## MINUTES OF MEETING

### Rules Change Committee

#### 153<sup>rd</sup> Regular Meeting (No. 2019-06)

**Proposed Amendments to the WESM Manual on Metering Standards and Procedures**

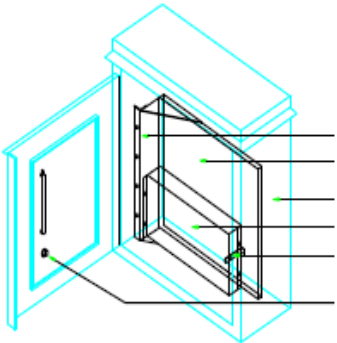
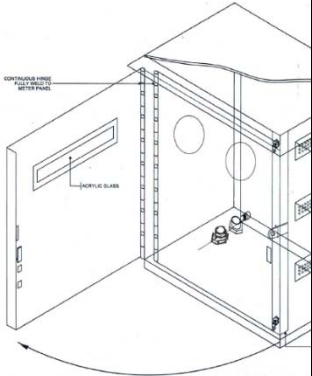
| Title  | Section  | Provision  | Proposed Amendment  | Rationale   | Stakeholder's Comment  | NGCP's Response  | RCC Discussion/ Agreements   |
|--------|----------|--|---|---|--|--|--|
| Figure | Figure 5 | <br><br>METER BOX ISOMETRIC VIEW |  | <ul style="list-style-type: none"><li>The revision is being proposed to provide revised design which can accommodate two meters (main and alternate) provided with security facilities consistent with PGC 2016 GRM 9.2.2.4 (a)</li></ul> | <p><b>IEMOP:</b></p> <p>References to current specifications in the annexes may require revisions in the manual every time the PGC and PDC standards are updated.</p> <p>References to current specifications are proposed to be deleted to remove necessity to revise manual every time the PDC standards are updated.</p> <p>Proposed Wording:<br/><br/>(proposed to be deleted)</p> | NGCP to IEMOP<br><br>NGCP recommends to maintain its original proposal | The RCC agreed with MERALCO's comment that the provided design of the meter box is just an indicative design. The body agreed to specify this in the appropriate Appendix. |
